Technical Bulletin / Safety Alert

Unique ID No: GEN2014-TBSA-02 **Rev:** 0

Subject: JUG-A-0 PTO Return Filter Housing Guard

Applicable to: ALL VLI JUG-A-0 UL/UV Machines (Where Installed)

Figure 1: Images showing the PTO Return Filter Housing a) as installed without guard, b) as installed with guard and c) an exploded view of the guard installation.

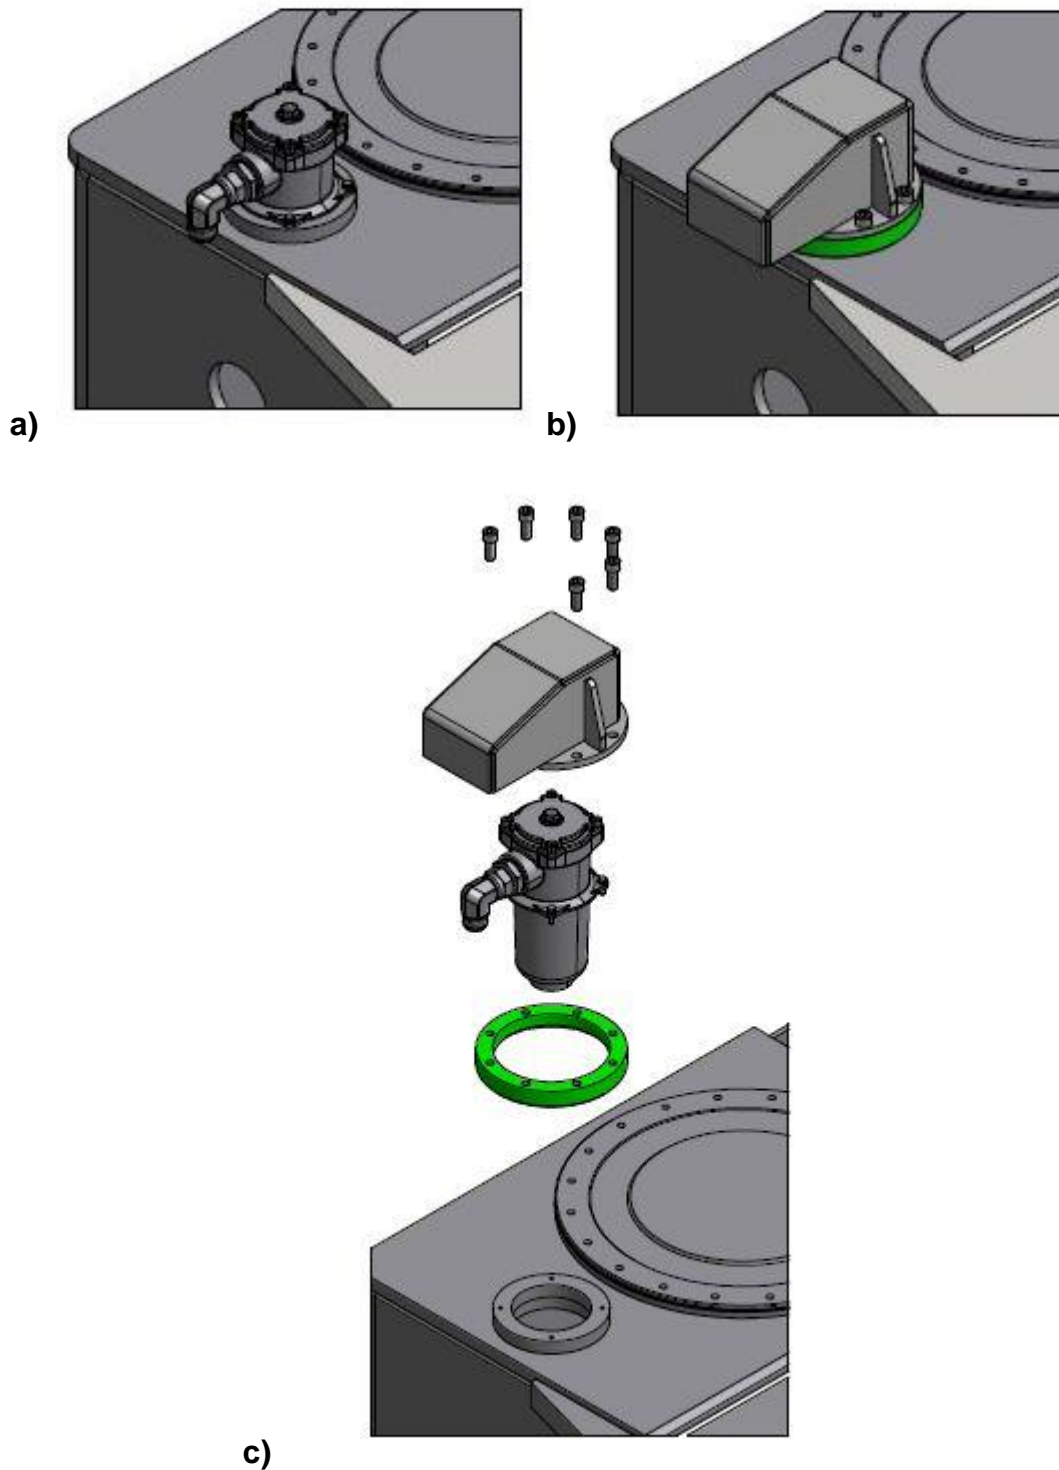
In response to a recent customer request, VLI advises the availability of an optional protective guard for the PTO Return Filter Housing installation on JUG-A-0 UL/UV Machines (where installed).

The PTO Return Filter Housing, where installed, is located on the top of the hydraulic oil tank, is of a cast aluminium construction and is potentially exposed to damage. The housing is currently protected via protective coating. The addition of the guard provides an increased level of protection.

The images in Figure 1 provide a representation of the PTO Return Filter Housing, the optional guard and an exploded view of the guard installation.

The installation of the new guard requires modification to the top of the hydraulic oil tank, and therefore it is recommended to contact VLI to discuss options for the installation of this guard.

| VLI Part Number | Description |
|------------------------|---------------------------------|
| 0508-60217 | PTO Return Filter Housing Guard |
